Date: February 26, 2018
CITY OF GREAT FALLS
DESIGN REVIEW BOARD

Item: 3527 10th Avenue South - Ace Hardware

Action Requested: Approve the submitted design with conditions.

1 SITE - NEW CONSTRUCTION
1" = 20'-0"

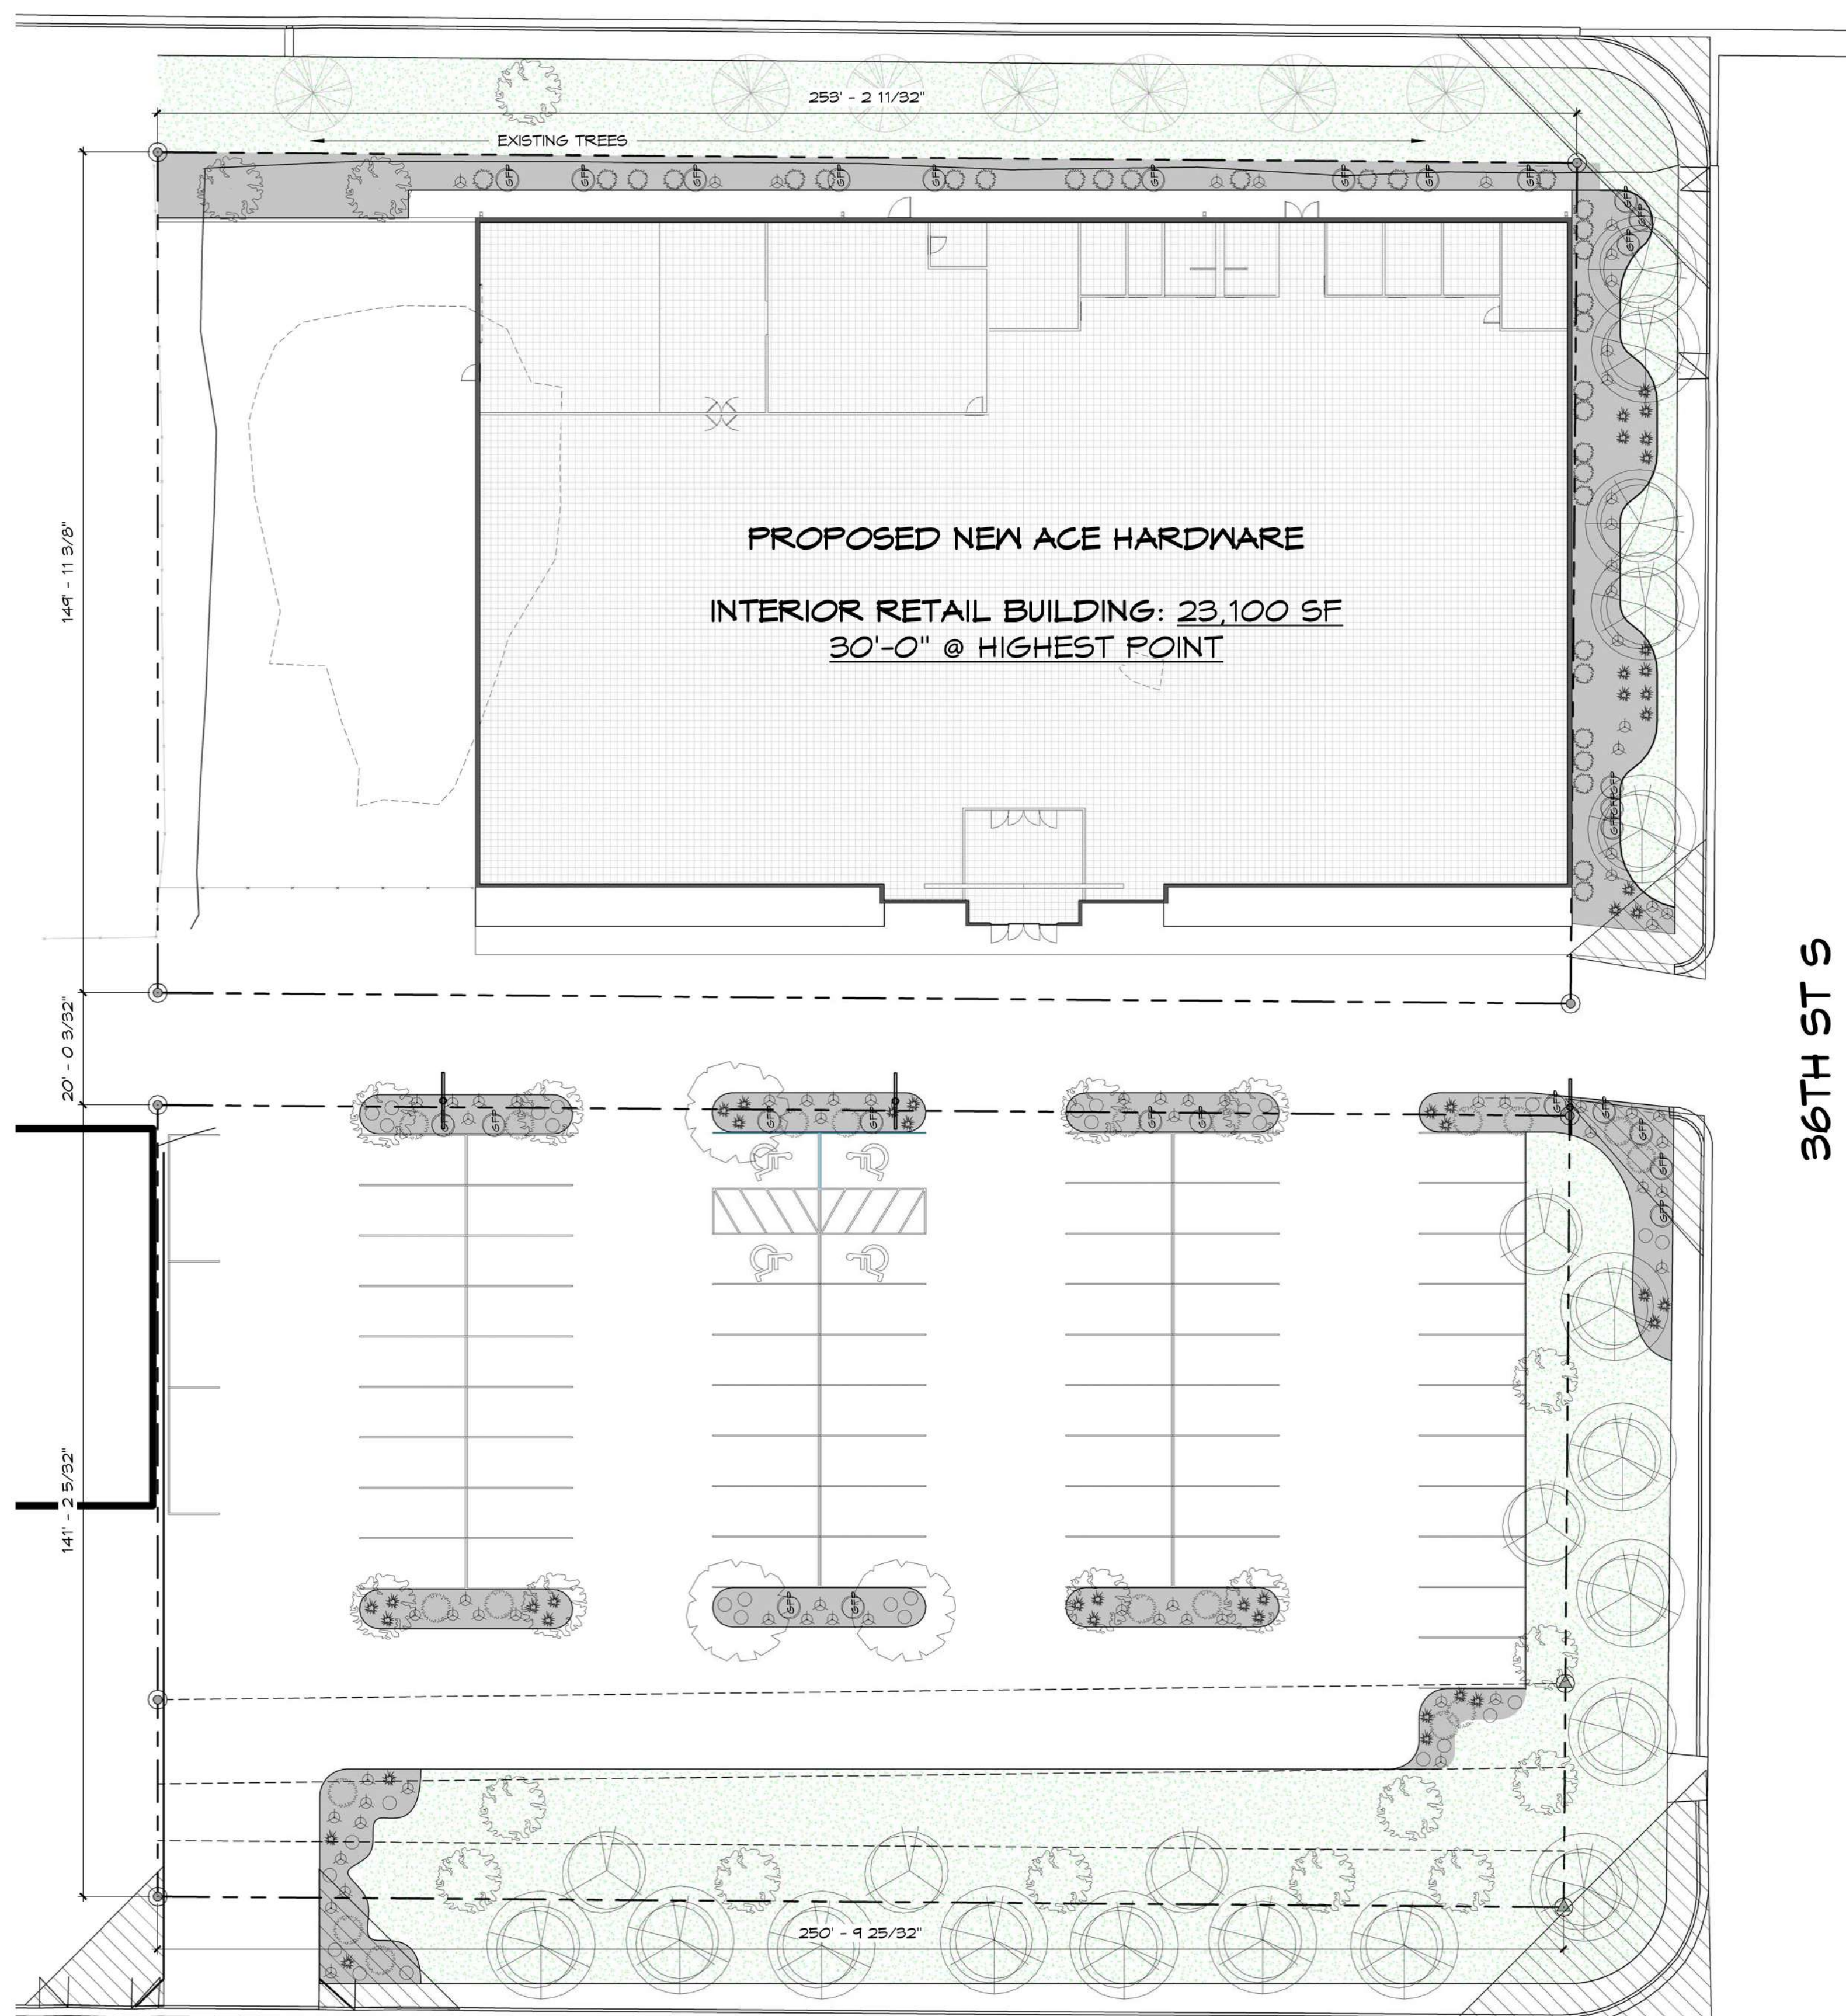
square feet of gross floor area. This would require the proposed hardware store to provide 77 parking spaces. Due to the existing site conditions, it is not feasible for the project to comply with the required parking space count and also comply with the stormwater management and landscaping requirements, therefore the applicant previously applied for a variance to reduce the amount of parking spaces. On February 1, 2018, the Board of Adjustment met on the mentioned variance and approved the applicant's request to reduce the minimum amount of parking spaces required by 7-10 spaces with the condition that a full stormwater submittal be provided to the Public Works Department. As a result of this decision, the applicant has provided 66 parking spaces, including a small reduction based on providing onsite bicycle parking.

Due to the location of the accessible parking spaces, a crosswalk will be required to direct those patrons to the entrance of the building. To keep the pedestrian out of the parking lot aisle, the landscape island will need to be modified to accommodate the crosswalk. The applicant will work with Staff to revise the plan to ensure that it is in compliance with all ADA requirements.

- A. The parcels to the north of the alley and the parcels to the south of the alley must be aggregated.
- B. Details of the proposed bicycle parking must be included in the permit submittal.
- C. The site plan must be modified to provide a crosswalk from the ADA accessible spaces to the entry of the building.
- D. All proposed work in the right of way along 10th Avenue South must be approved by MDT.

1 LANDSCAPE PLAN - NEW CONSTRUCTION
1" = 20'-0"

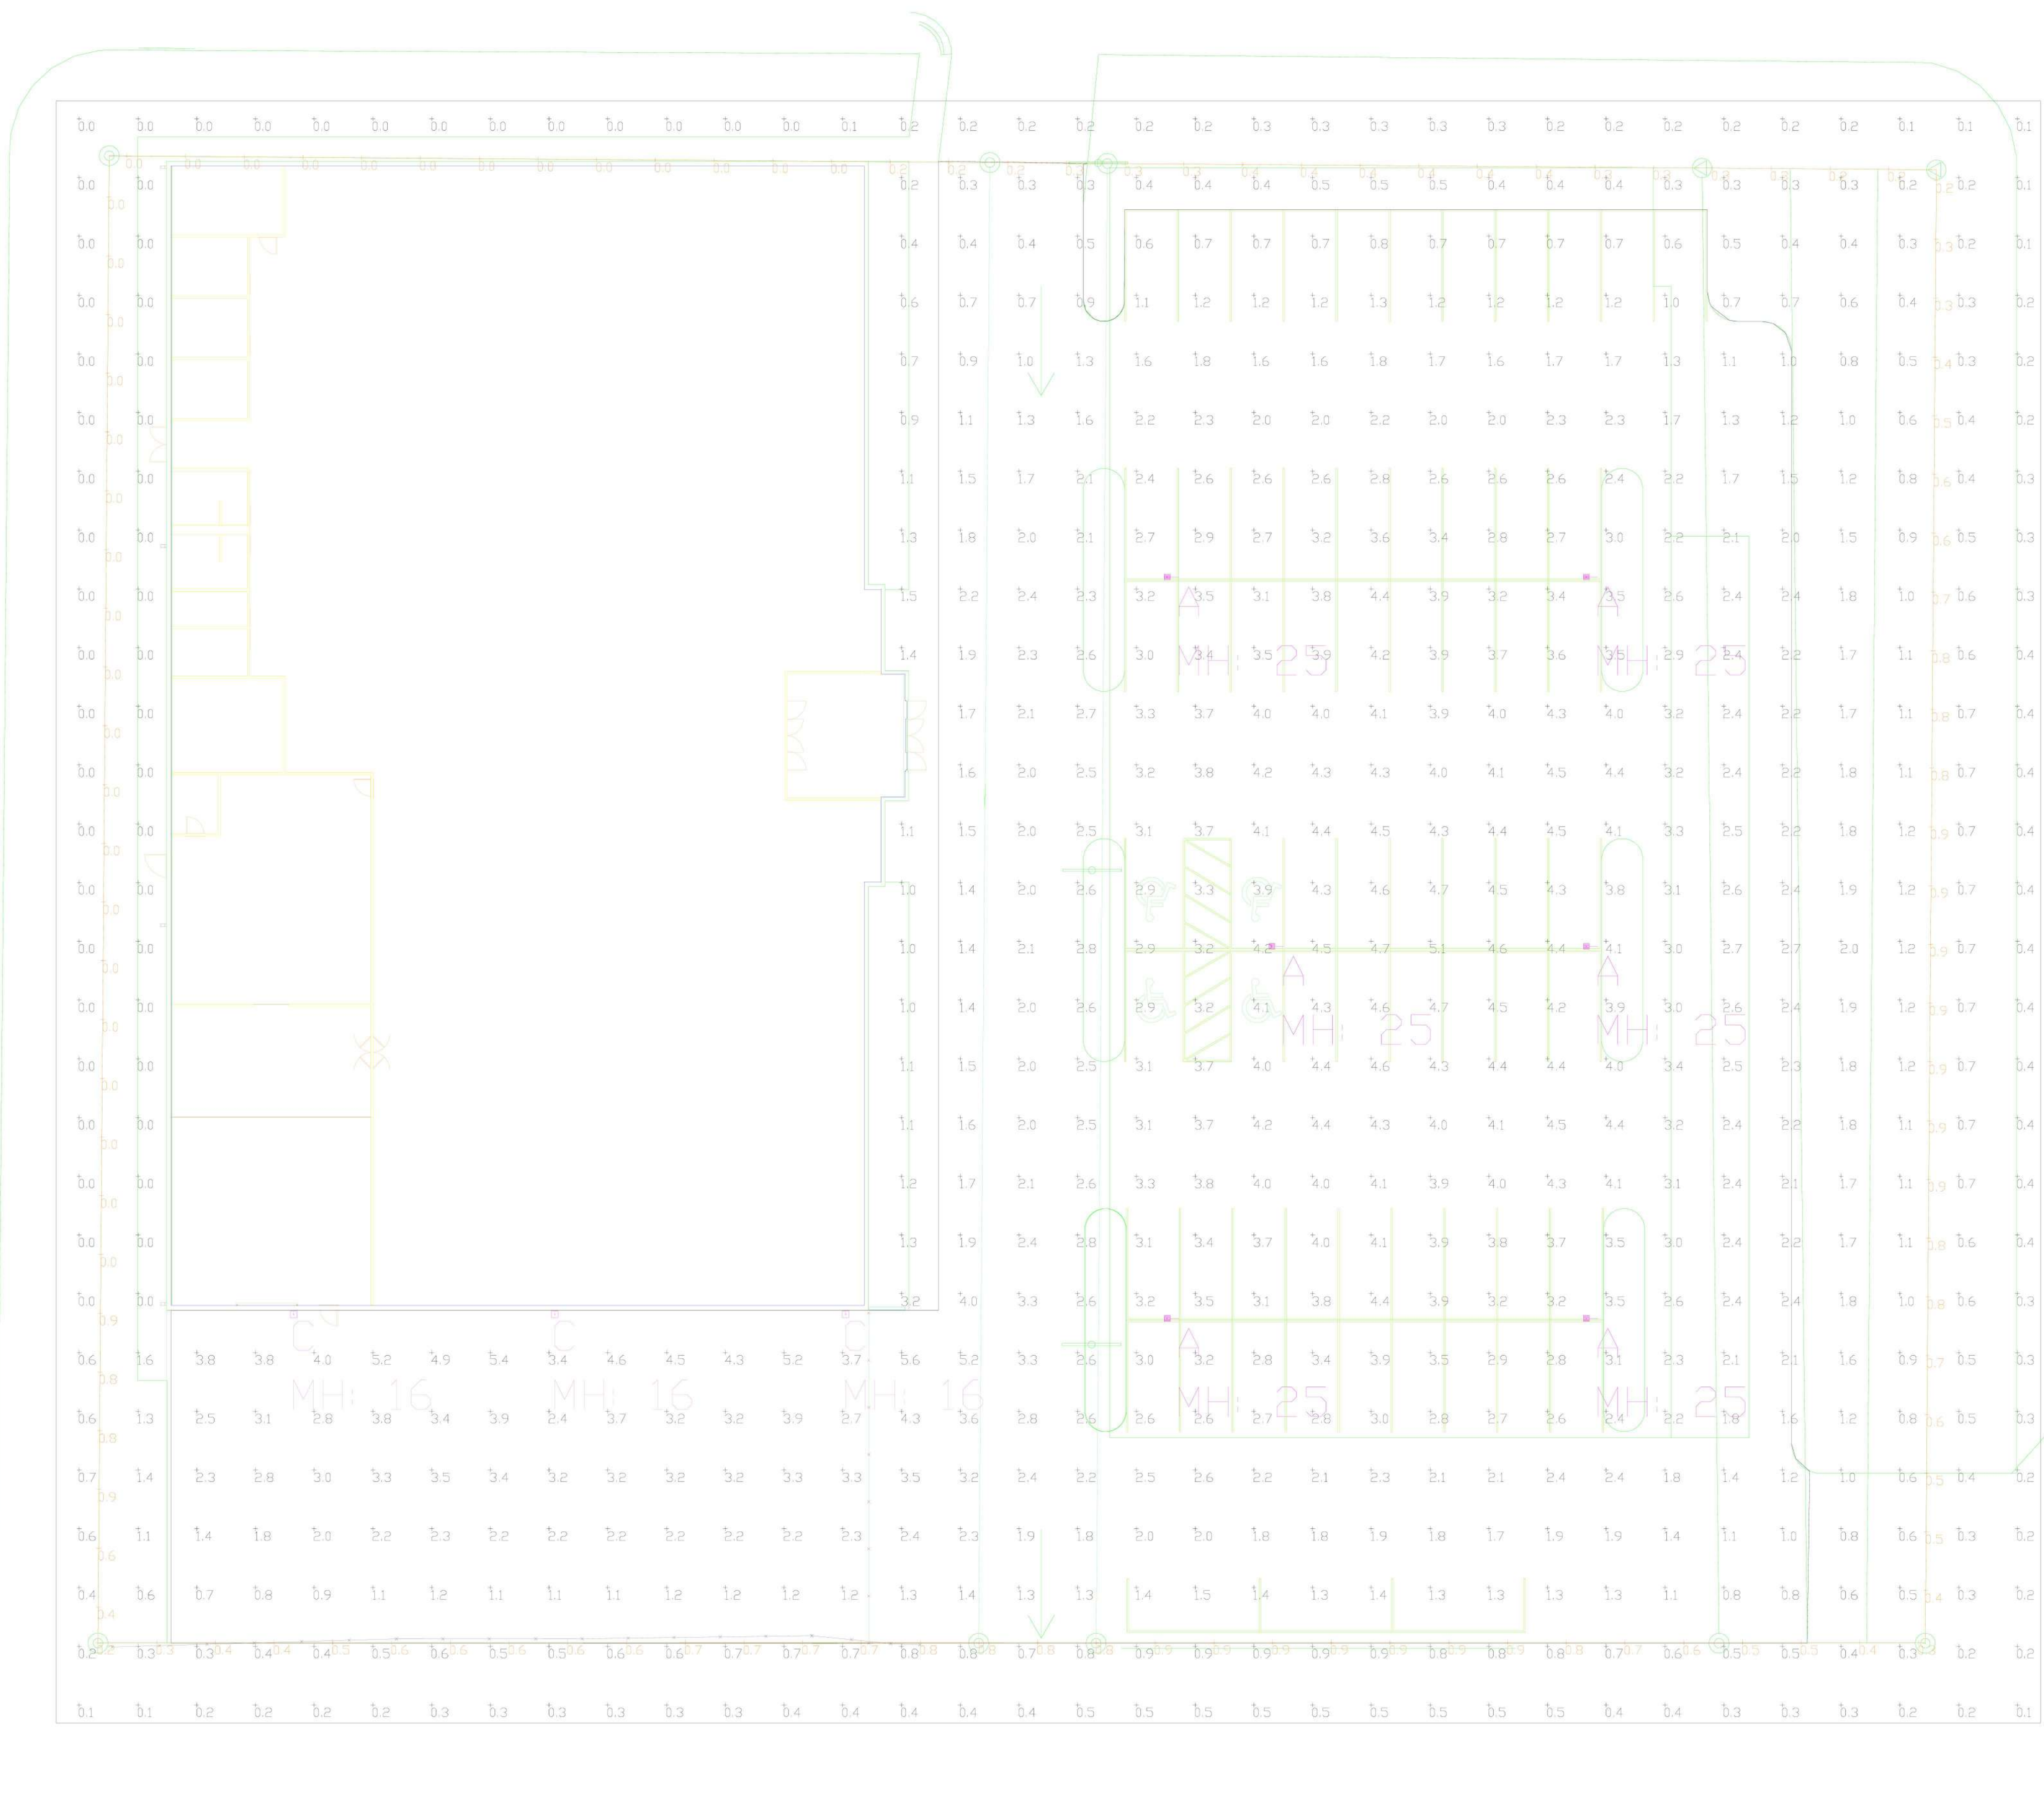
The OCCGF further requires one (1) tree and seven (7) shrubs planted per four hundred (400) square feet, or fraction thereof, of required interior landscaping. The landscape plan requires 28 interior trees and 193 shrubs, for compliance with the OCCGF. The landscape plan requires revisions to be in compliance for the required rate of planting. The project representative has conveyed that a Landscape Architect will be hired to revise the landscape plan once the civil drawings have been completed and will work with Staff during the permit process to ensure that the landscape plan will be in compliance with the OCCGF.

- C. Landscaping is required to be designed and installed along the north facade of the building in lieu of compliance with guidelines 18 and 25 of Exhibit 28-1, to soften the facades. Final landscaping must comply with all requirements of the OCCGF.
